cm-baosh-synchronization-comments- on-D0-4-0916

Geoffrey M. Garner , Shenghua Bao
gmgarner@alum.mit.edu , baoshenghua@huawei.com

2016-09

Question -1

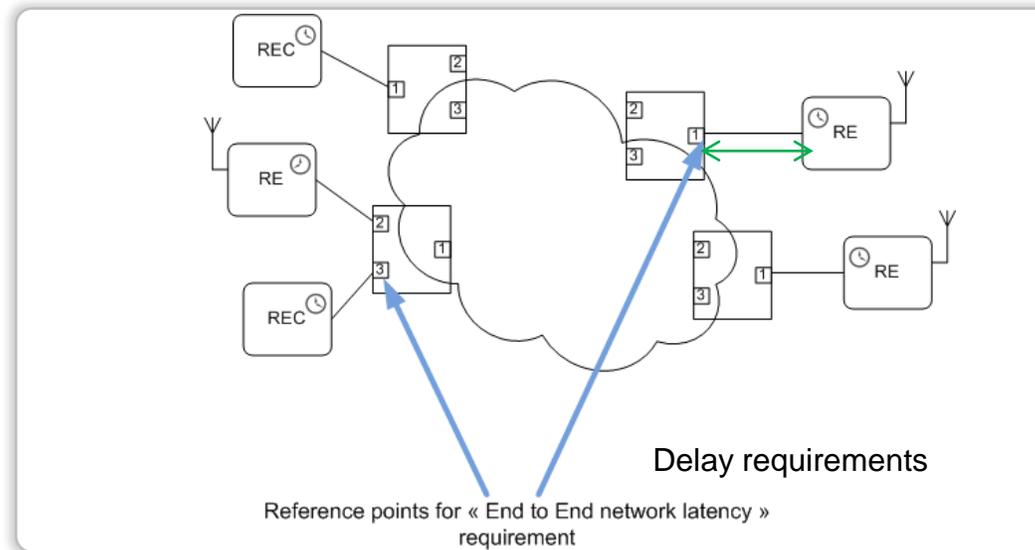
- For Class A+, A and B: The timing error of the slave clock in the RE compared to the nearest common BC or TC (between the REs that running a feature that require the specific class)..
- Question:
 - Whether the timing error between the RE and the fronthaul boundary node connecting with this RE (as shown in green) should be included in the timing error requirement path ?
 - If yes, then, when the timing requirements can not be satisfied, who is responsible for the failure ? the fronthaul network? Or the wireless system?

- According to the latency requirements(100us), the paths of the delay requirement are all located between the two boundary points of the network, which does not include the path between RE and fronthaul boundary node (as shown in green) .
- We should add some figures to the specification to describe the delay and timing requirements boundary. And especially for the timing requirements , we should figure out who is responsible for the timing error budget allocation between network and RE/REC.

Question -2

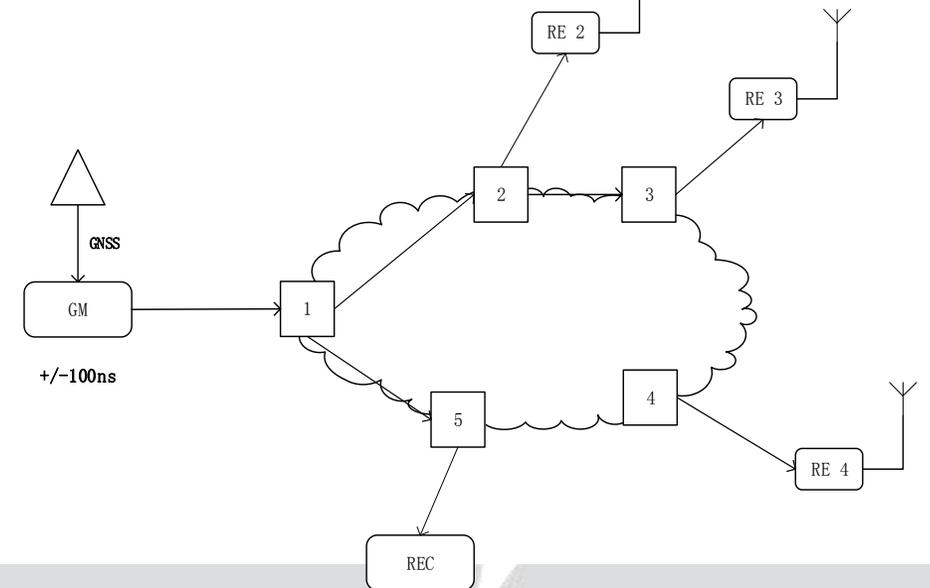
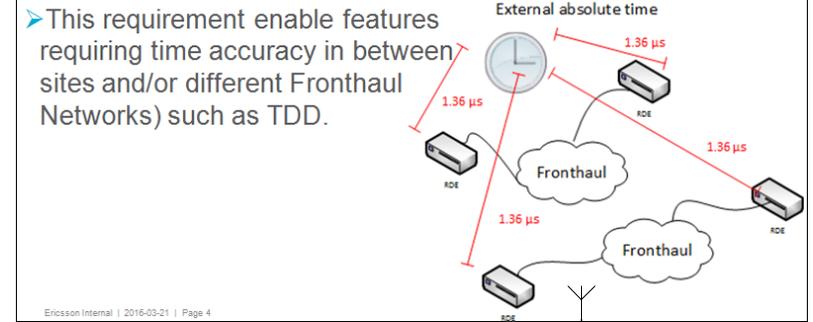
- For Class C, the time/phase accuracy for RE's time relative to an external absolute time
 - $\leq 1.36 \mu\text{s}$ (- wireless internal budget $\sim 40 \text{ ns}$ – GM 100 ns)

- Time error 100ns for GM is based on ITU-T G.8272 recommendation.
- However, ITU-T is considering an enhanced GM clock in G.8272.1 (e.g., $\pm 30 \text{ ns}$), the error of GM is improving.
- We think that the error for GM is not in the CPRI or .1CM work scope, it's better to keep this to ITU-T. Then timing error requirements of class C and D should be amended.

Network Level Reference Models and Reference Points

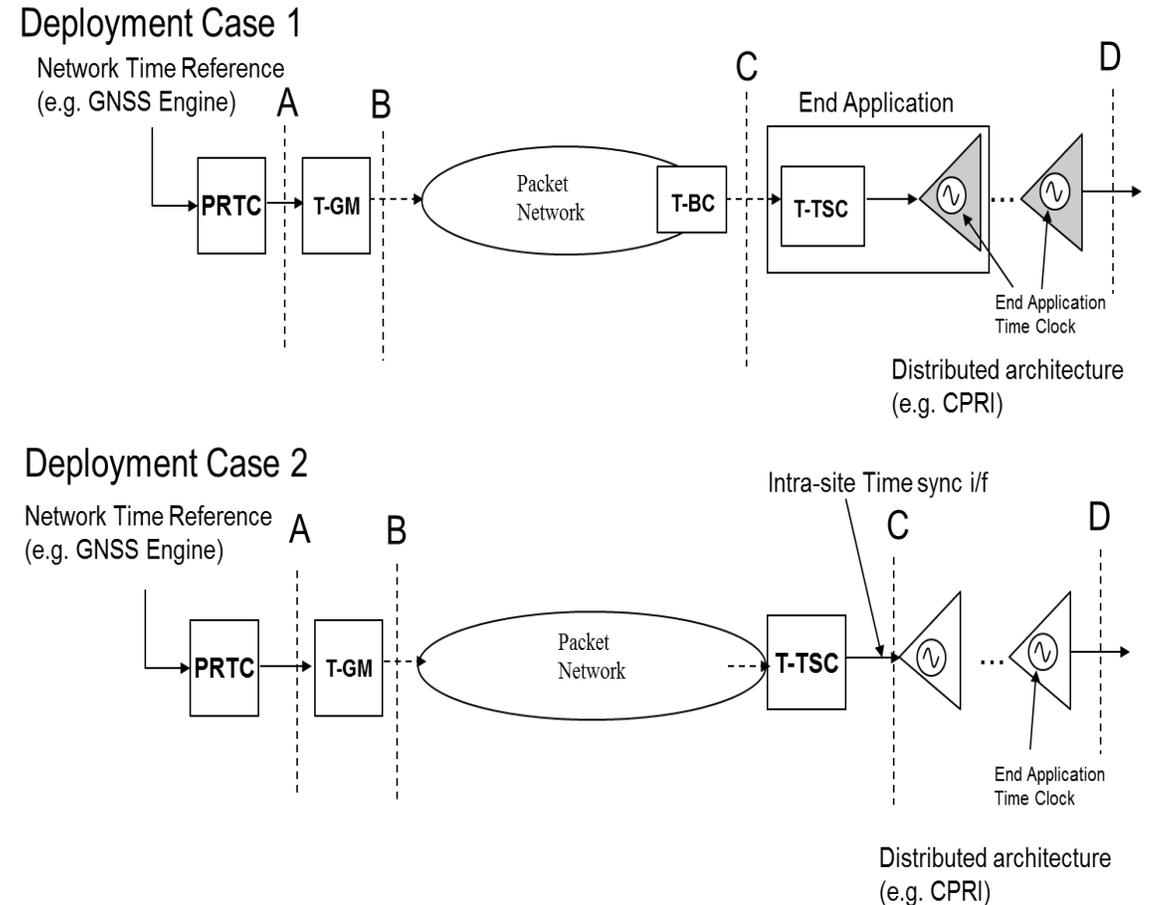
- The requirements summarized on slide 5, for classes A+, A, B, and C are not very clear on exactly where in the network the requirements apply
- Network-level specifications developed in ITU-T Q13/15 clearly show reference points in the network where the specifications apply (i.e., they show a reference model)
- For example, the reference model for backhaul in G.8271.1 is shown on the right:

- In the reference model for backhaul on slide 7, the end application clock is not specified by ITU-T (it is specified by 3GPP)
- For eCPRI, the end application clock is part of the RE or REC, and is specified by the CPRI group
- Therefore, the requirements in 802.1CM should be specified at the equivalent of reference point C of the figure on the slide 7, but for a reference model for eCPRI rather than for backhaul
 - This is between the final network node and RE or REC
 - If the Time Telecom Slave Clock (T-TSC) is collocated with the RE or REC, this point is in between the final Telecom Boundary Clock (T-BC) and T-TSC
 - If the T-TSC is separate from the RE (or REC), this point is in between the T-TSC and RE (or REC)

- For the case of eCPRI, clearly show a reference model with a figure, with the relevant reference points indicated
- The time accuracy requirements for eCPRI should be at a reference point between the network and RE or REC (analogous to reference point C in the backhaul reference model)
- The reference can apply to all four timing requirements classes
- With the reference model, indicate that the relevant timing budget allocation will be defined by ITU-T
 - Work is beginning in ITU-T SG 15, Q13
